66AK2Hxx
Multicore DSP+ARM KeyStone II SOC
Silicon Revisions 1.0, 1.1, 2.0, 3.0, 3.1

Silicon Errata

Literature Number: SPRZ402F
June 2013–Revised June 2018

Figure 2. SRIO SerDes in Loopback Mode

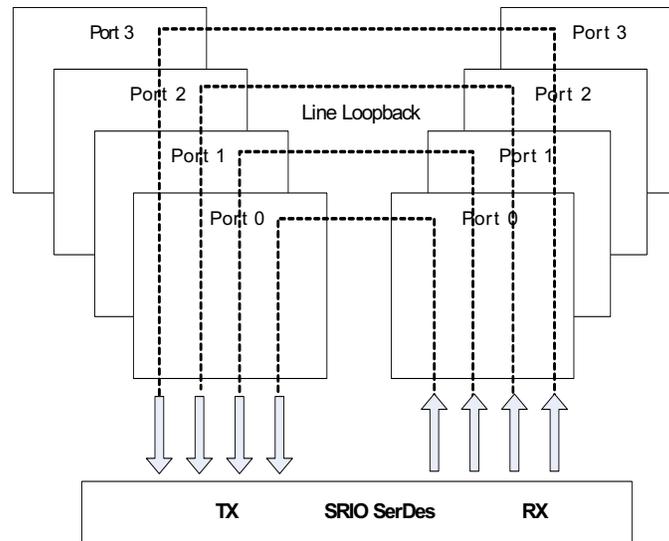
When line loopback is enabled on one or more SRIO ports, any valid 10b code group that decodes to an illegal control character as defined by the RapidIO Specification (Revision 2.1) and whose most significant bit is 0, will be corrupted on transmission. This issue can be summarized as follows:

- 10b code group -> Legal control character -> No problem
- 10b code group -> Illegal control character and most significant bit is 0 -> Corruption

Instead of using PRBS sequences, users can qualify boards by using RapidIO-compliant data on the link and monitoring either per-lane error counters or port-level error counters. RapidIO-compliant data is less stressful than PRBS sequences, as the RapidIO-complaint 10b data has shorter 0s and 1s run lengths than PRBS sequences. Hence, RapidIO-compliant data represent a more accurate stimulus for this test. This should be acceptable for users whose RapidIO links are of short reach, which can be either 20 cm + 1 connector or 30 cm without a connector.

Figure 3. Software Reset Using the RSTCTRL Register

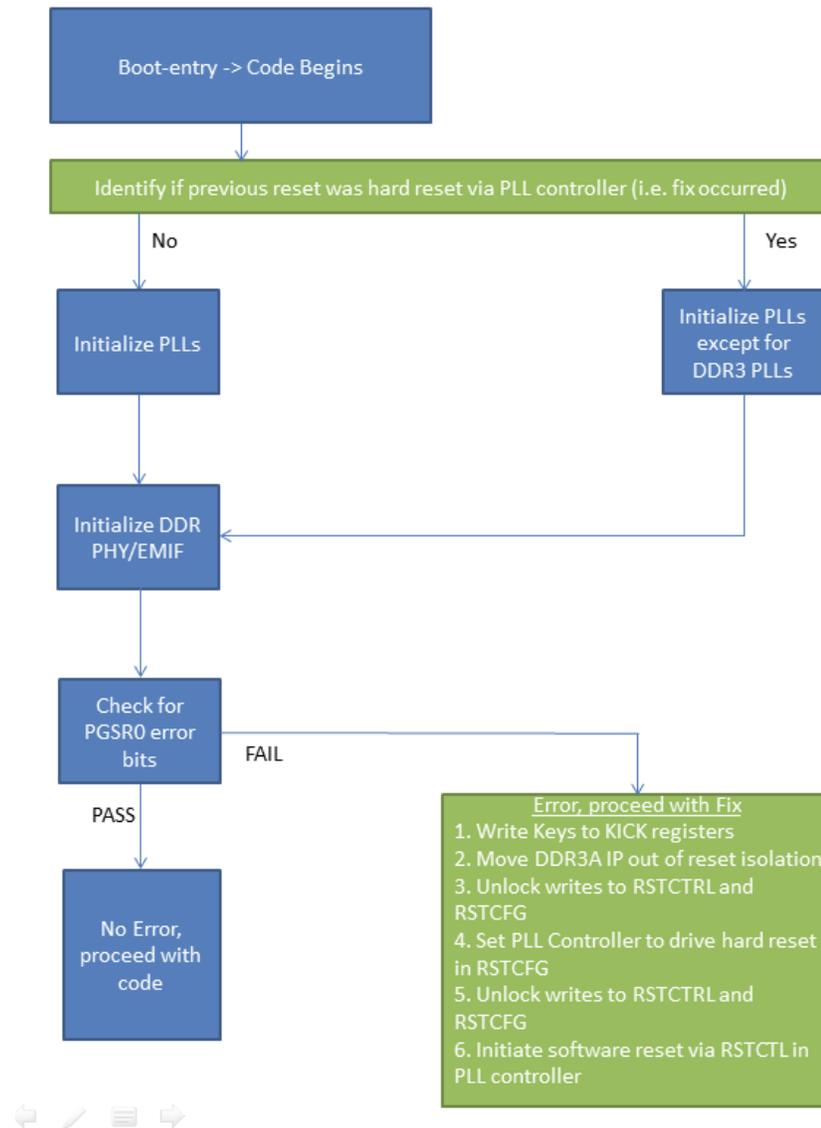
The root cause is identified to an issue that happens after the very first DDR3 PHY initialization, this first initialization happens directly from Power-on reset. The issue occurs because the clocking requirements of the DDR3 PHY are not met on the first initialization, this happens because the DDR3A and DDR3B SoC PLLs are not yet programmed to provide the requisite clock. There is a ratio requirement between the DDR3A/B PHY clocks and the core configuration clock, such that the core configuration clock must be less than or equal to the PHY clock. These clocks are asynchronous and the PHY support an asynchronous FIFO scheme with limited depth on the PHY clock domain. If the ratio requirement is not met then FIFO can overflow. This would mean that the configuration data for the PHY may be lost during the initialization sequence. Experiments have proven that if we apply Hard Reset once the clocking has been set up correctly, the issue is resolved.

This workaround is to detect this error in the PHY Init function and apply Hard Reset to the device. Hard Reset of the device can be done by performing the following:

BLUE colored blocks show the normal execution while the GREEN colored blocks show the changes. The “Error, proceed with Fix” block is the block which explains the steps that need to be followed to apply the Software Reset using RSTCTRL register. The steps are mentioned for DDR3A. The same steps need to be used for DDR3B also.

10GbE PCB Channel Loss Limited to 20dB

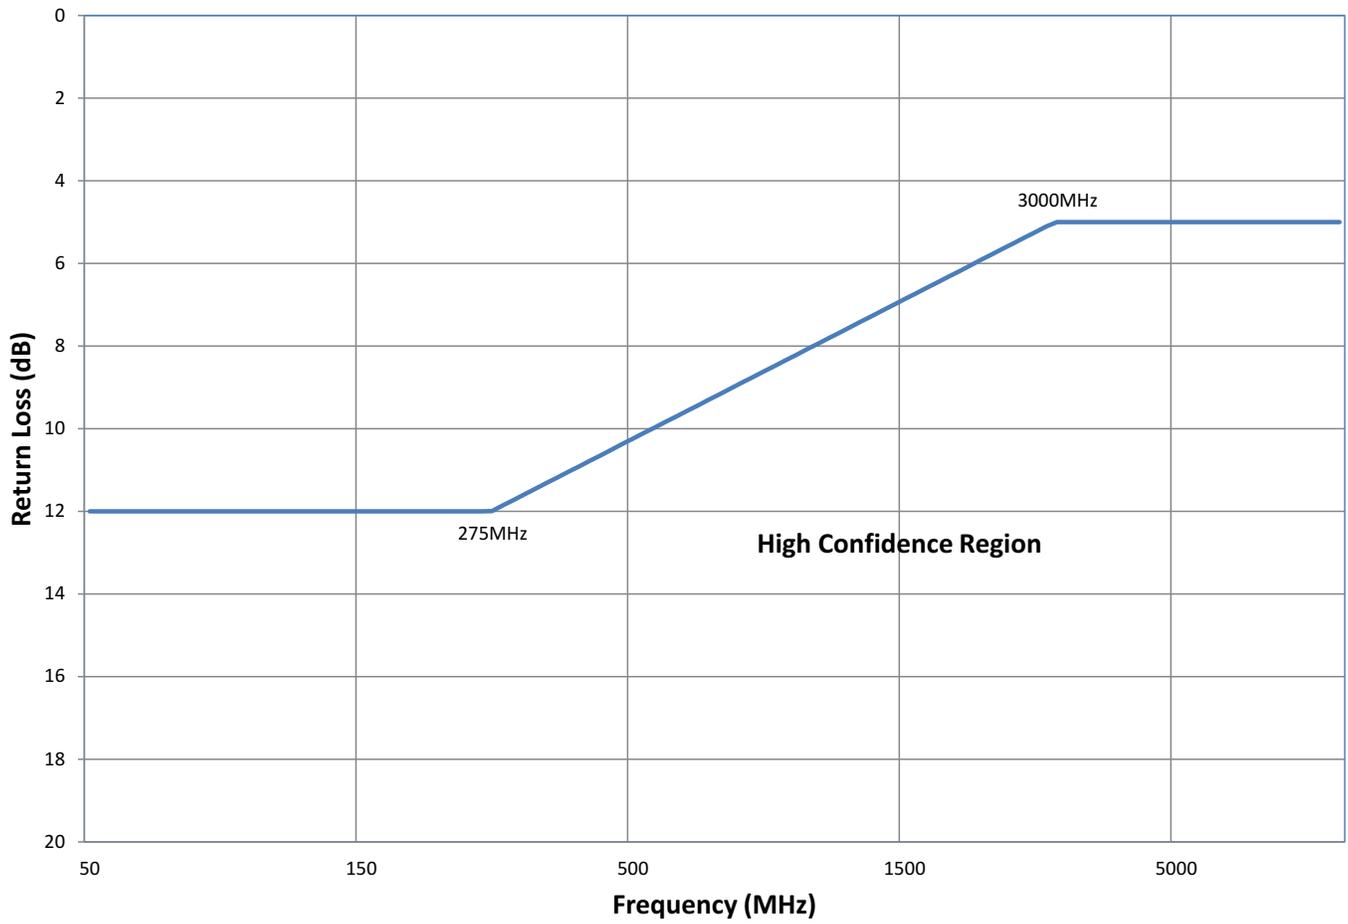
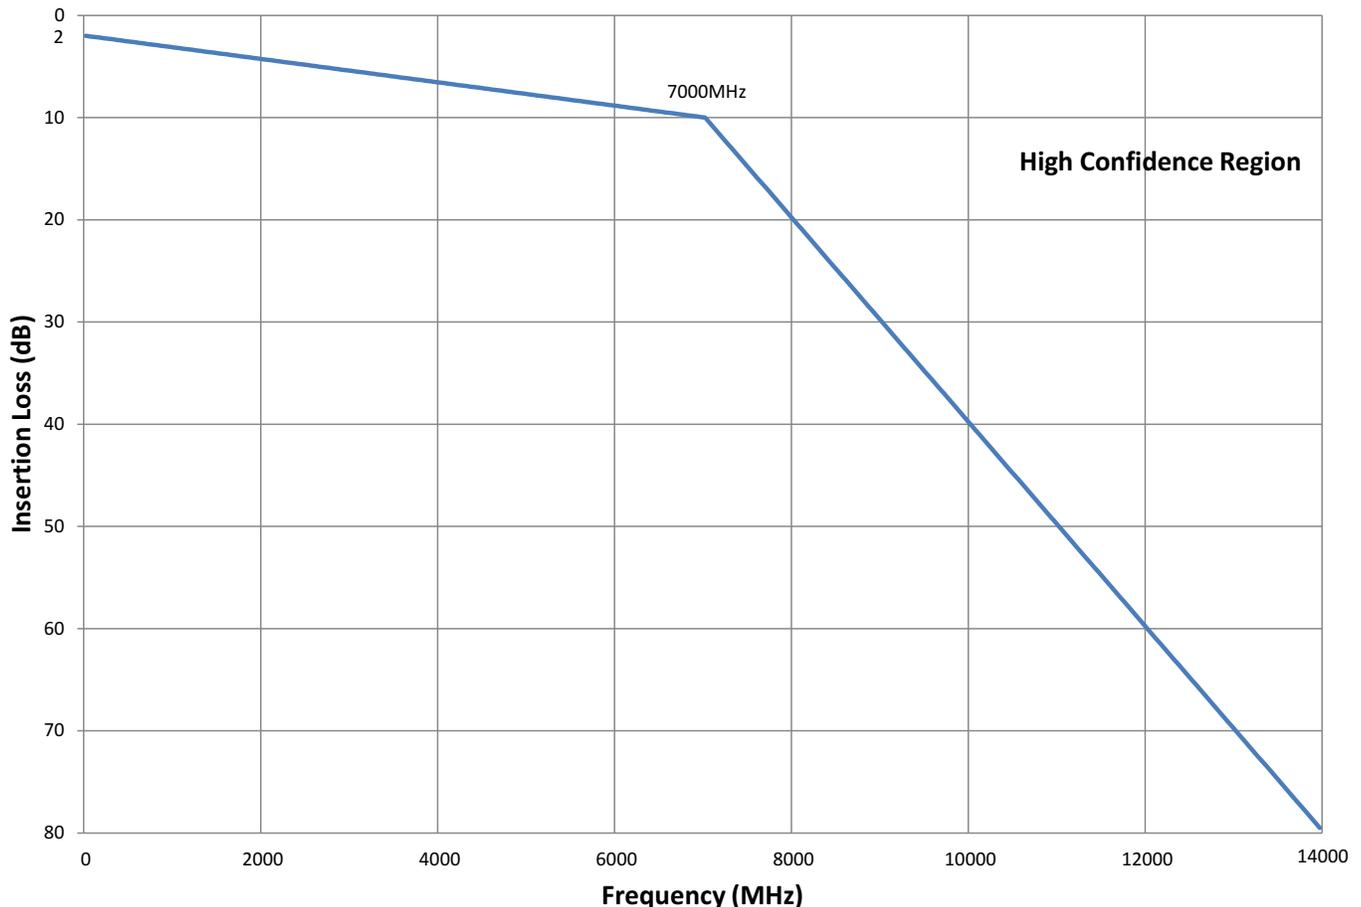
Device characterization has shown that bit error rate performance consistent with the 10GbE-KR standard as published in IEEE 802.3-2008 Annex 69B cannot be met across all device operating extremes. Production devices do operate at the required error rate across all rated operating conditions of voltage and temperature when the channel insertion loss is limited to 20dB at the Nyquist rate of 5.15625GHz. The figure below shows the Insertion Loss template from IEEE 802.3-2008 Annex 69B as well as the reduced Insertion Loss template.

Characterization has shown that channels must also be compliant with the Return Loss template contained in the IEEE 802.3-2008 Annex 69B specification without modification. This is shown below for convenience.

KeyStonell.BTS_errata_advisory.31
HyperLink Channel Loss

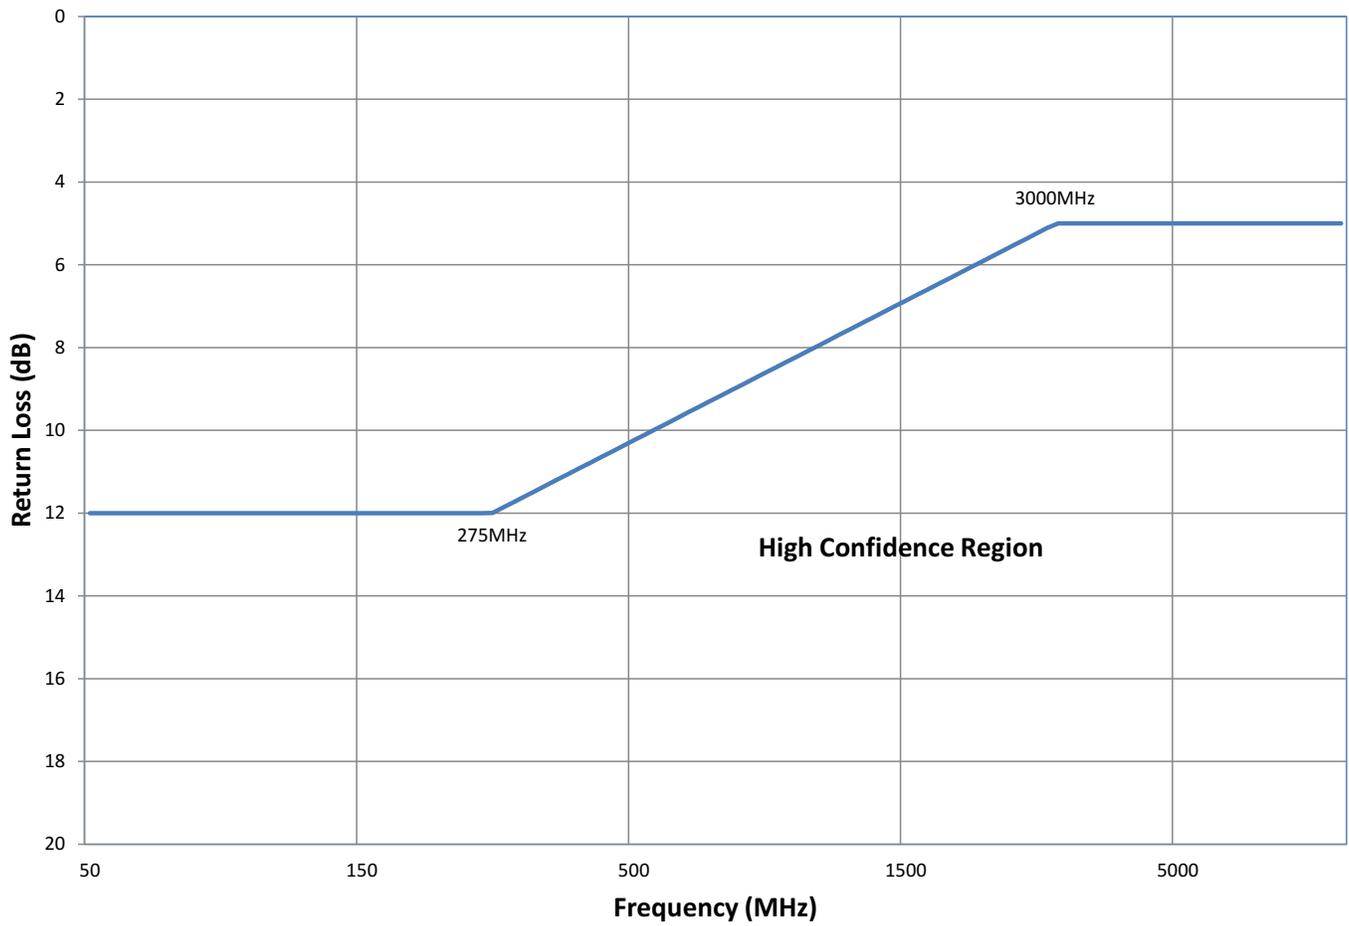
Device characterization has also shown that channels should be compliant with the Return Loss template shown below. The Return Loss measurement indicates the amount of energy reflected back to the source which is not available to the receiver. Impedance variation in the channel will cause reflected energy that can cause this template to be violated. Careful attention to PCB construction and layout must be followed to meet this requirement. This template must be met for the entire channel from transmitter to receiver including the series capacitors. Note that this is the same template

defined in IEEE 802.3-2008 Annex 69B specification for 10GbE.

Figure 5. DDR3 PHY

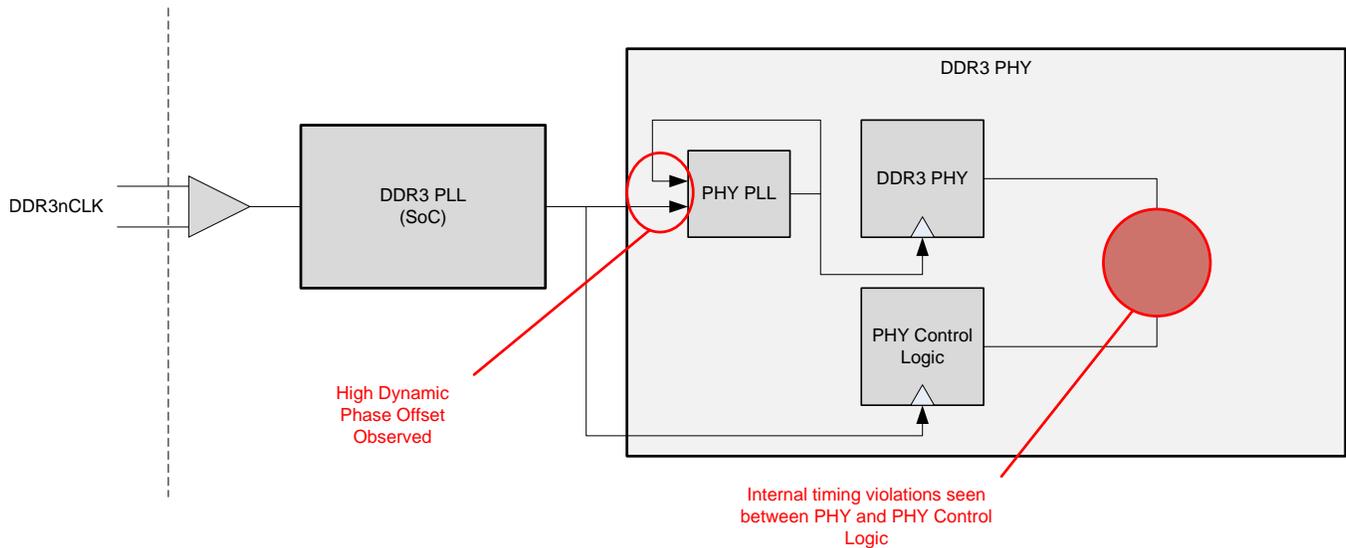
Details: DDR3 read operations may show errors due to increased levels of Dynamic Phase Offset (DPO) inside the DDR3 PHY. These errors are characterized by byte lane data corruption or intermittent bit errors. The byte lane data corruption can only be recovered using a device reset.

The Dynamic Phase Offset (DPO) is a measure of the DDR3 PHY PLL’s ability to track rapid phase changes in the output of the DDR3 SoC PLL. High DPO can create internal timing violations between the DDR3 PHY and DDR3 PHY Control Logic and result in data errors during reads. As indicated by the shaded red circle in the figure above, the timing violations occur in the data transfer between the PHY and PHY control logic. It was determined that the root cause of the elevated DPO were SoC PLL and PHY PLL configurations that were non-optimized for the timing requirements of the system.

The workaround for this behavior is a change in the PLL configurations used for the DDR3 SoC PLL and the DDR3 PHY PLL. New configurations have been generated for DDR3-1600, DDR3-1333, DDR3-1066, and DDR3-800 operation and are presented in the tables below. Per field alert, "DDR3 Limited to Highest Data Rates Due to Possibility of PLL Instability During Temperature Changes after Startup", operation of DDR3-1066 and/or DDR3-800 is not recommended for affected Keystone2 devices in production systems

Figure 7. Hang Scenario

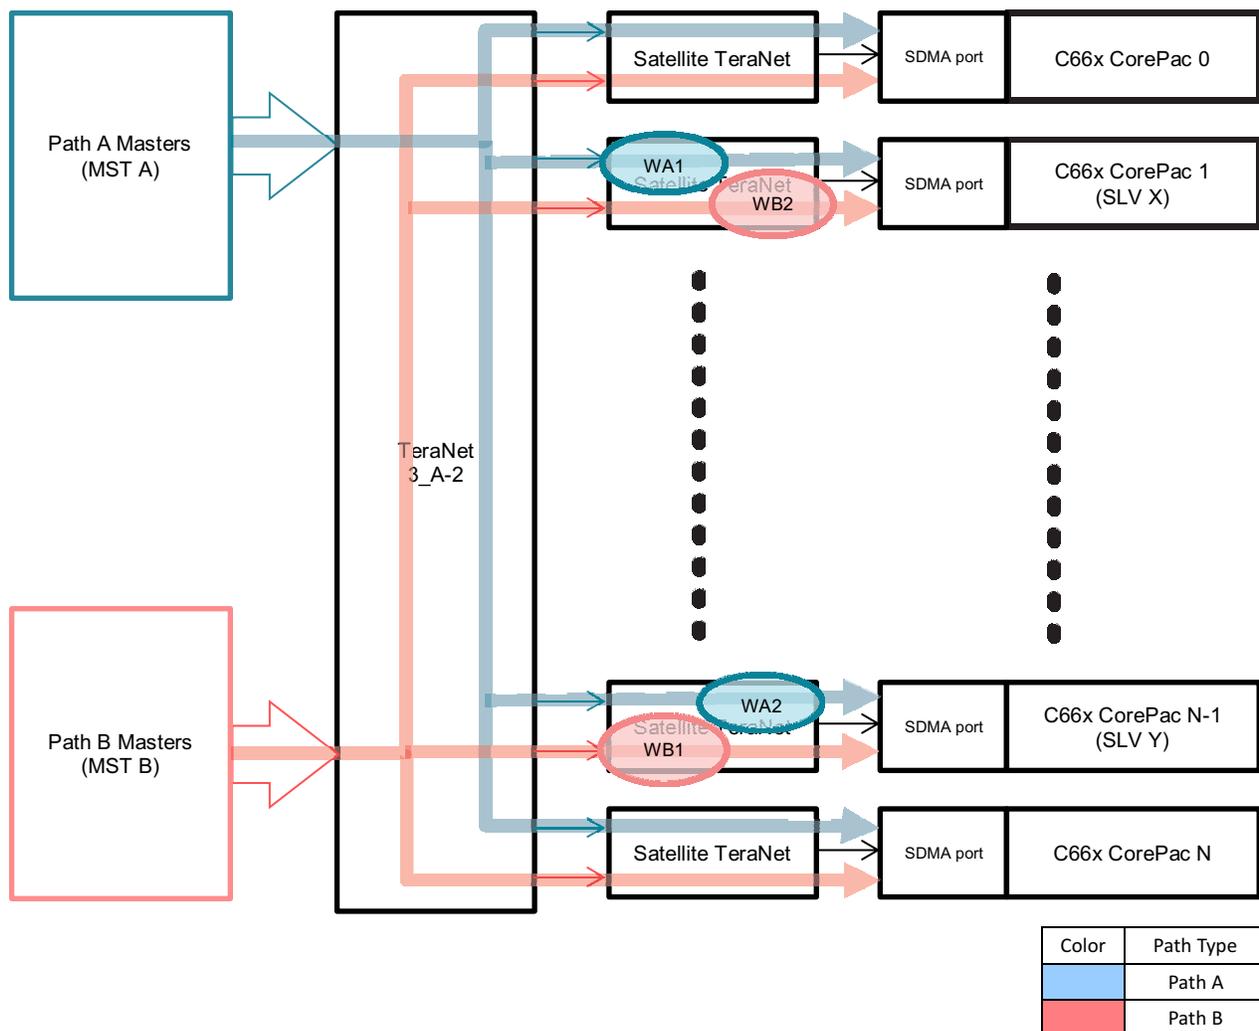
Hang Scenario: When a master (MST A) that uses path A and another master (MST B) that uses path B send out two writes each (WA1, WA2 and WB1, WB2) to two C66x CorePac slave end points (SLV X, SLV Y), a hang can occur if the following conditions occur:

- Both masters send one write to each of the two slave end points in opposite order:
 - MST A sends two writes: first write WA1 to SLV X, and second write WA2 to SLV Y
 - MST B sends two writes: first write WB1 to SLV Y, and second write WB2 to SLV X
- Writes from two masters arrive on separate paths at slave endpoint:
 - MST A writes arrive on path A
 - MST B writes arrive on path B
- Both slaves are busy, so they stall the incoming write transactions.
- Both slaves select second writes when they are ready:
 - SLV X selects WB2
 - SLV Y selects WA2

Figure 10. RX Path Block Diagram

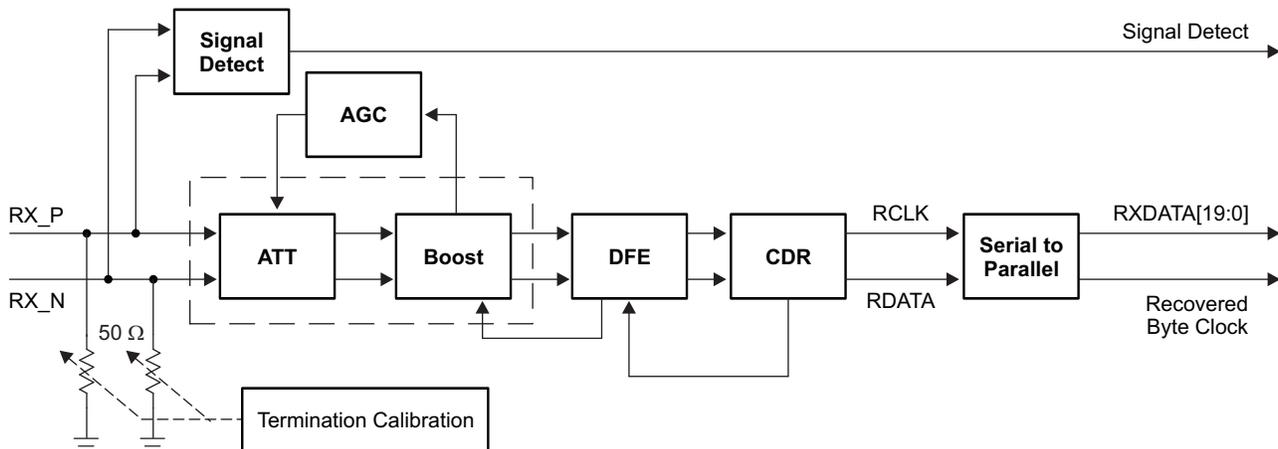
Details The TI SerDes contains an adaptation algorithm that allows the RX equalization blocks to adapt their parameters to the SerDes data channel. The adaptation algorithm sets the optimal values for the ATT, BOOST, and DFE blocks in order to equalize the signal, maximize margin, and minimize channel distortion. For higher data rates (i.e. 5Gbps and greater), the high frequency gain provided by the BOOST block is generally considered necessary to compensate for the low-pass characteristics of data channels and widen the data eye.

The SerDes BOOST block was designed to require a specific set of patterns in order to best adapt its parameters to the channel. If these patterns are not found, the BOOST adaptation algorithm will not update the internal block settings and/or may incorrectly update these settings. The required data pattern is a series of six 0's followed by a 101 pattern. This pattern must occur numerous times on both odd and even bit alignments. This data pattern is not present in the 8b/10b coded symbols that are sent over many of the high speed peripheral links.
